PROGRESS REPORT

Independent Review of Implementation of Revised Seismic Design Criteria Hanford Waste Treatment and Immobilization Plant (WTP)

Revision D

U.S. Army Corps of Engineers
Walla Walla District

Figure SM-7-1

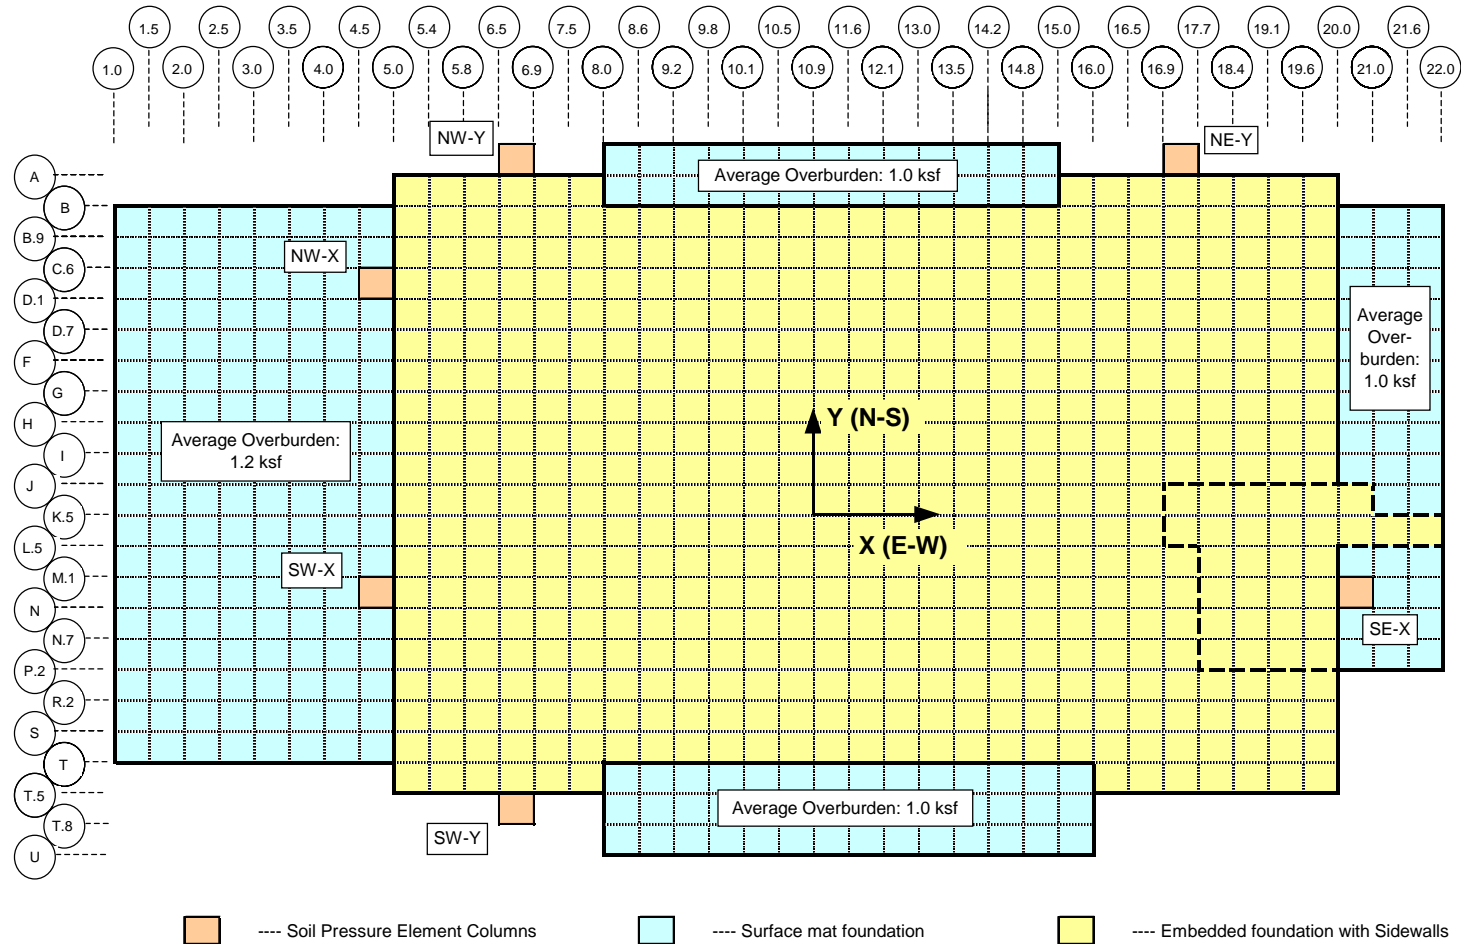
C.2 Structural Modeling Review Comments Phase I				
No.	Document	Comments and Observations	BNI Remarks/ Resolutions	Follow-up by USACE Review Team
			<p>following the end of this resolutions table.) Figure SM-7-1 shows the overall layout of HLW model Rev. 0A at grade. Figures SM-7-2, -3, and -4 show the soil pressure time histories at selected embedment depths at the three most critical locations, i.e., the soil columns NW-Y, NE-Y and SW-Y where there is no floor mat at grade. In these figures, the “Static Envelope” line is the calculated static soil pressure at the elevation. The magnitude and duration of dynamic soil pressure exceeding the static envelope are clearly illustrated in the figures.</p> <p>It should be noted that the above conclusion was reached for the Rev. 0A structure and the embedment was modeled conservatively such that the 6 ft. thickness of the foundation mat at El. -21’ was ignored. Later modifications of the structure design, including the additional grade floor mat on the southern side of HLW building, have the effect of increasing the size of the static envelope and therefore reducing the potential separation between soil and structure. Therefore, the conclusion is still valid.</p> <p>2nd Response: This response is to clarify the additional comments made by the reviewer.</p>	<p>The reviewers should be able to review the entire calculation for it to be convincing that there is no significant reduction in lateral soil support. Is this analysis documented in the structural summary report? If not, the calculations should be made available to the reviewers.</p> <p>It is not clear how the static soil pressure is computed at 1.25 feet below grade. The value of 0.27 ksf (scaled from Fig. SM-7-2) is much greater than obtained from $0.11 \text{ kcf} * 1.25 \text{ feet} * k_0=0.5$ that equals 0.07 ksf. By the same approach, the static pressure at 17.5 and 19.75 feet below grade is about 30% higher than the values on the figures.</p> <p>The peak soil pressures at 1.25, 17.5, and 19.75 feet below grade scaled from Figures SM-7-2 thru SM-7-4 are 0.85, 1.0, and 1.72 ksf, respectively. The same values from the recent SSI calculation (Figure 7-48) are 2.3, 1.4, and 3.5, respectively. As a result of the differences in static and dynamic soil pressures and because only a small part of the calculation is presented, there is</p>

Figure SM-7-2

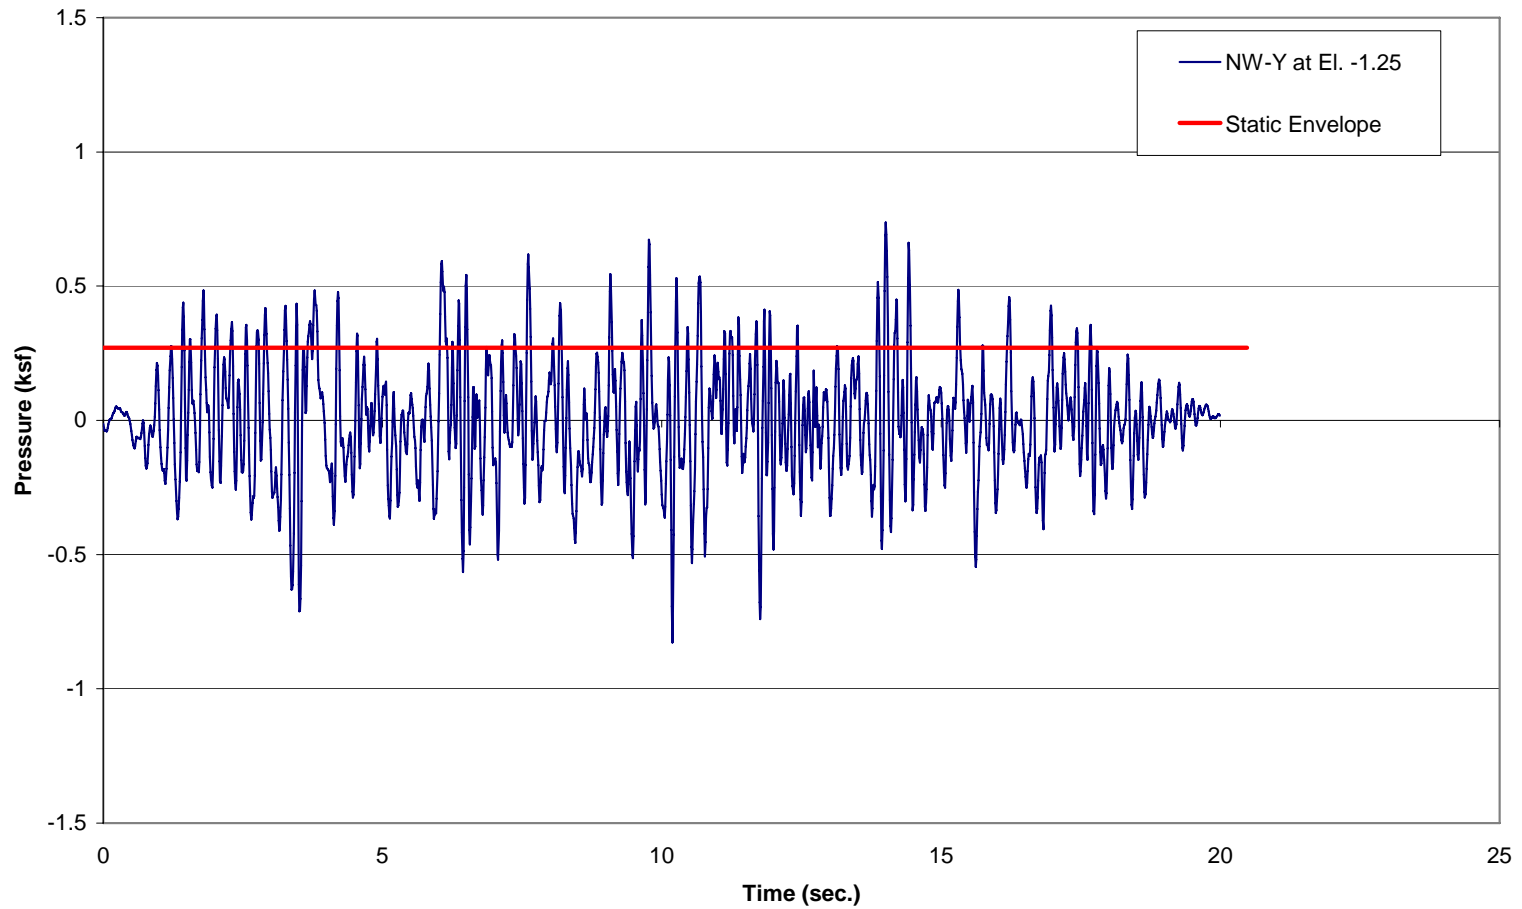
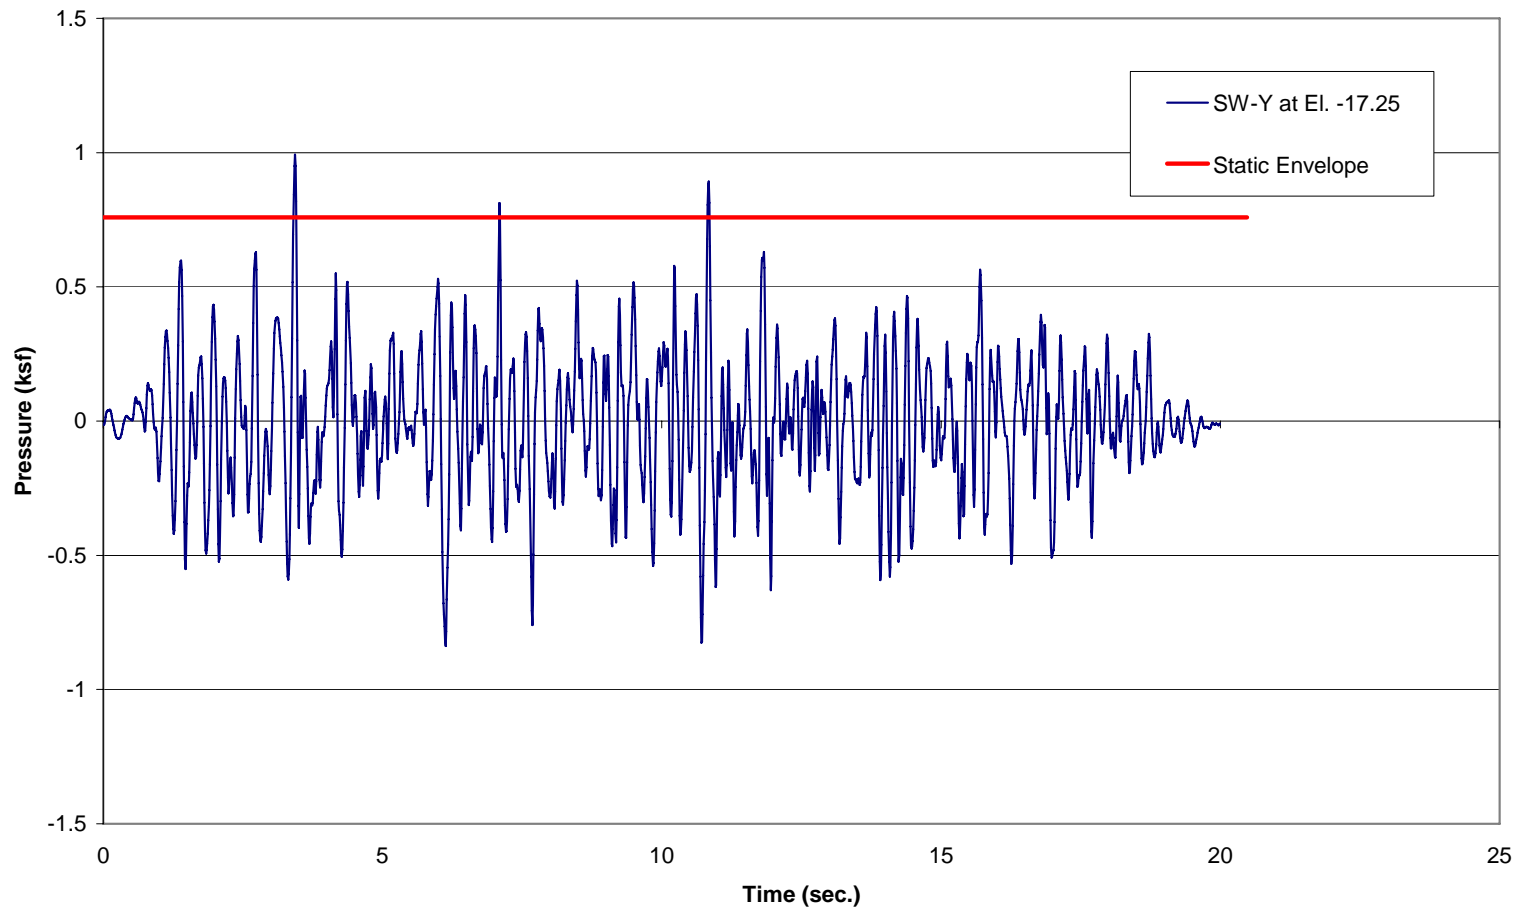
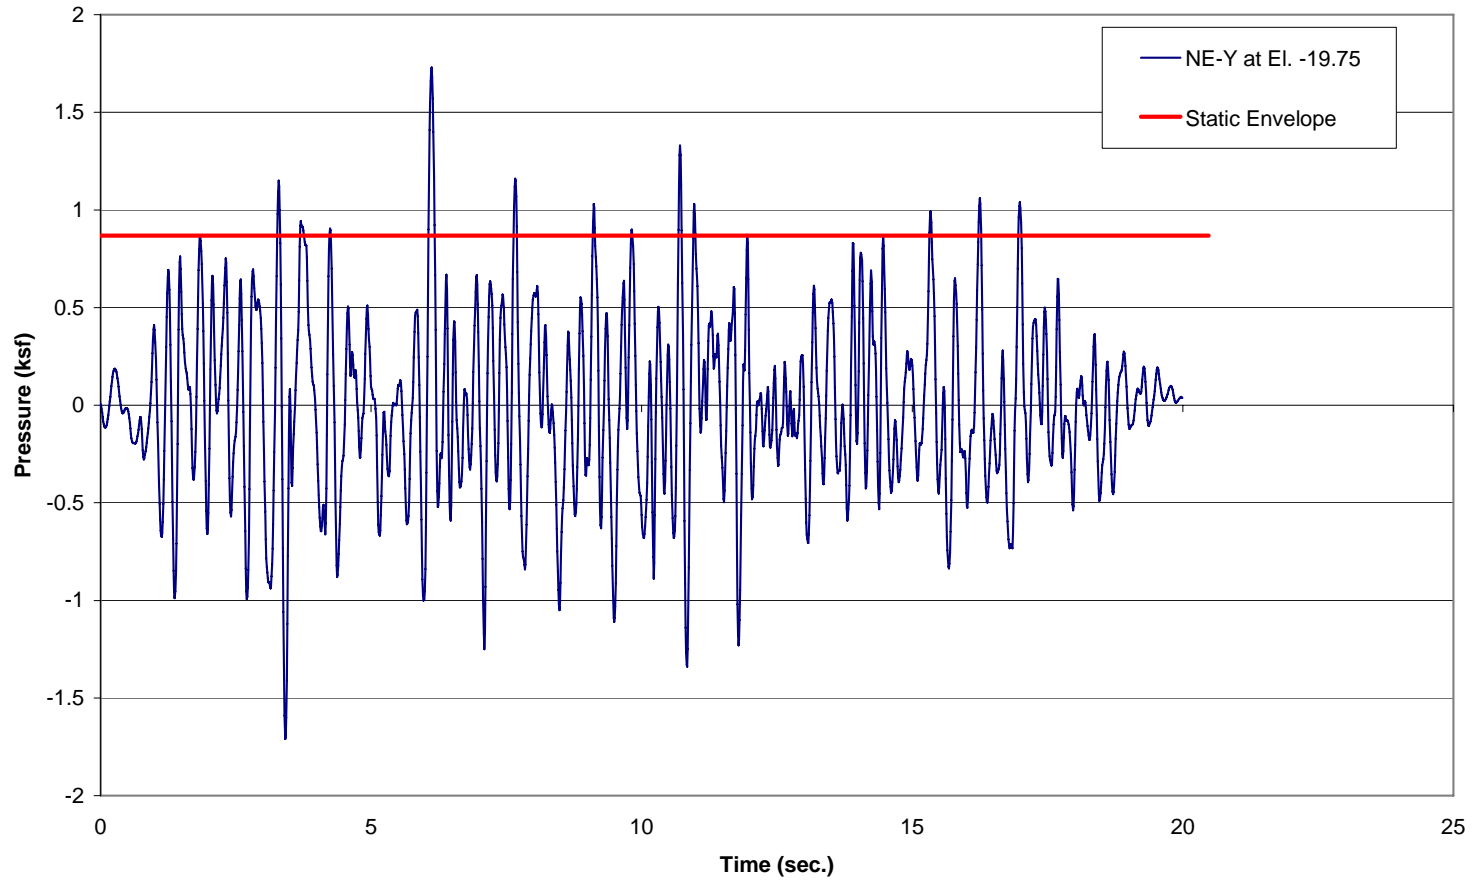
C.2 Structural Modeling Review Comments Phase I				
No.	Document	Comments and Observations	BNI Remarks/ Resolutions	Follow-up by USACE Review Team
			<p>The static lateral earth pressure values as shown in Figures SM7-2 through SM7-4 were calculated as the combination of the following components: (Figure SM7-5)</p> <ul style="list-style-type: none"> • Insitu lateral soil pressure due to soil weight as recommended in the WTP Geotechnical Report. • A large portion of the side walls are adjacent to extended surface basemat foundation with an average overburden pressure of 1.0 ksf, generating additional lateral pressure of 0.36 ksf. • Underground structure was constructed by open-pit excavation. Backfill soil adjacent to the sidewalls was compacted, generating additional compaction-induced lateral soil pressure on the sidewalls. This pressure varies with depth and reaches a maximum value of 0.52 ksf. at 3 ft. depth, then reduces to zero at about 15 ft. depth (as recommended in the Geotechnical Report) <p>The additional comments regarding the differences between the results from the parametric study, which is the basis of the figures SM7-1 through SM7-5 and is based on the HLW Rev. 0A model, and the results of the latest HLW Rev. 0D model, will be answered in response to</p>	<p>not a convincing story that there is no significant lateral soil support.</p> <p>2nd Follow-up: The at-rest lateral coefficient appears to be 0.36 rather than 0.5 as assumed in the comment. However, there are additional static lateral pressures due to compaction and overburden. This seems reasonable. This closes the comment from the standpoint of the static pressures except that it would have been desirable for this to have been documented in the SSI calculation. The dynamic pressures questions have been resolved in response to SM-85.</p>
